From: Dock, Joel
Sent: Friday, January 24, 2020 8:38 AM
To: siobhan@sheangelo.com
Subject: 19-msub-0016 highlands preserve

**Re: Highland Preserve
Case No. 19-MSUB-0016**

Re: case #19-MSUB-0016

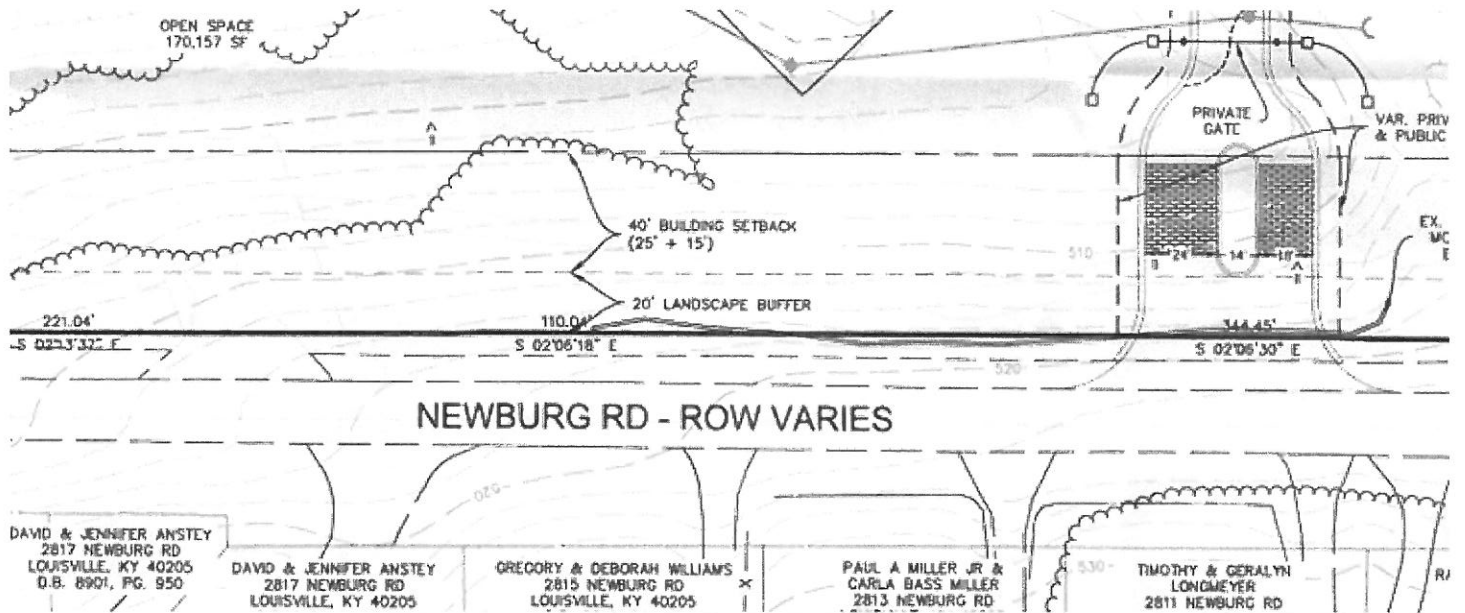
I am looking at the plans for proposed the subdivision. Attached is a snapshot of the 20ft "landscape buffer", and gate that will be on Newburg road. This is also referred to as a wall. The "wall" will be modified to allow for the private gated entrance that will sit on Newburg. Included in this info is a screenshot of tree canopy detail.

* What is considered a landscape buffer, also referred to as a wall. 20ft is two stories, correct? A landscape buffer is a dimensional requirement across the ground moving from a property line inwards towards the development. It buffers the development with plantings and/or screening form lower intensity uses or roadways. The wall that is being shown on the plan is existing and will be modified to allow for access. We need further clarification as to what this will look like. Bushes, brick, wood? Is there a color rendering available showing what is being proposed? Detail on the design of the gate has not been provided. I'll request from the applicant.

* Gated entrance is on Newburg road and looks to sit 15' off of Newburg Rd (if I am reading this correctly). Kelli Jones from SWL Developer had stated she wasn't sure where it was or how far back it sits. Can this gate be moved to Schuff Lane and help alleviate the additional traffic on Newburg Rd? The gate is shown roughly 60' from the new right of way line or roughly 120' from the pavement of Newburg Road.

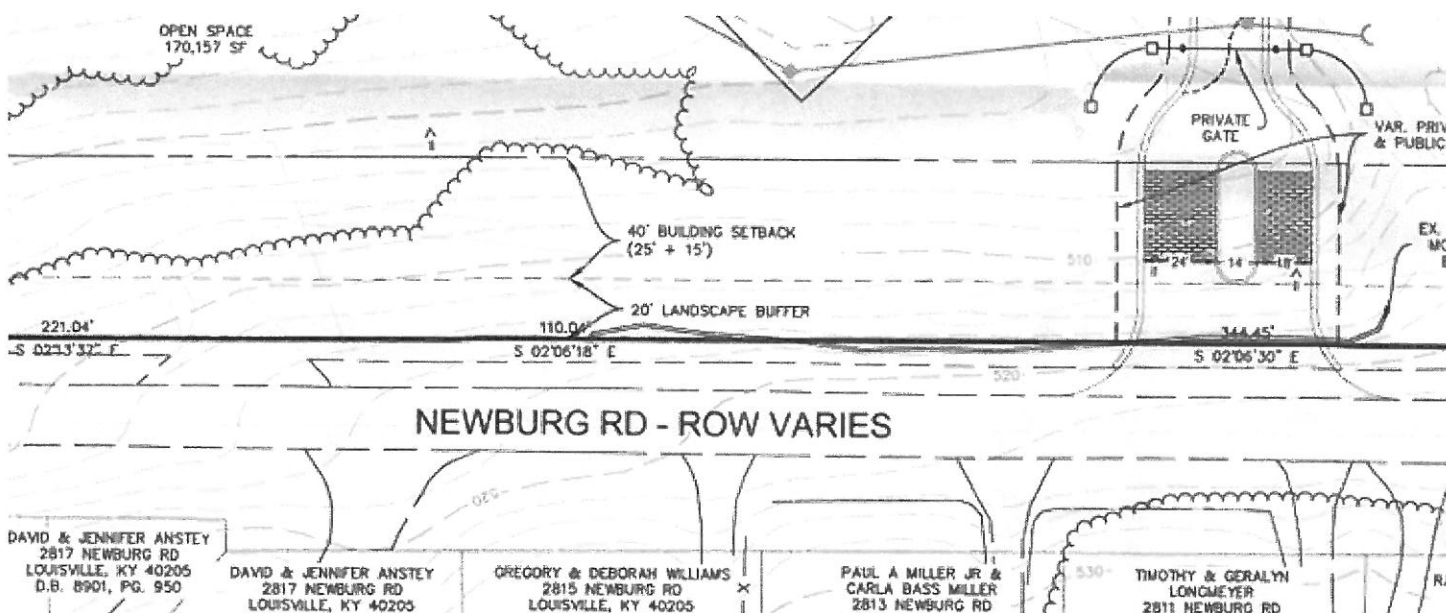
I am looking at the plans for proposed the subdivision. Attached is a snapshot of the 20ft "landscape buffer", and gate that will be on Newburg road. This is also referred to as a wall. The "wall" will be modified to allow for the private gated entrance that will sit on Newburg. Included in this info is a screenshot of tree canopy detail.

- * What is considered a landscape buffer, also referred to as a wall. 20ft is two stories, correct? A landscape buffer is a dimensional requirement across the ground moving from a property line inwards towards the development. It buffers the development with plantings and/or screening form lower intensity uses or roadways. The wall that is being shown on the plan is existing and will be modified to allow for access. We need further clarification as to what this will look like. Bushes, brick, wood? Is there a color rendering available showing what is being proposed? Detail on the design of the gate has not been provided. I'll request from the applicant.

- * Gated entrance is on Newburg road and looks to sit 15' off of Newburg Rd (if I am reading this correctly). Kelli Jones from SWL Developer had stated she wasn't sure where it was or how far back it sits. Can this gate be moved to Schuff Lane and help alleviate the additional traffic on Newburg Rd? The gate is shown roughly 60' from the new right of way line or roughly 120' from the pavement of Newburg Road.
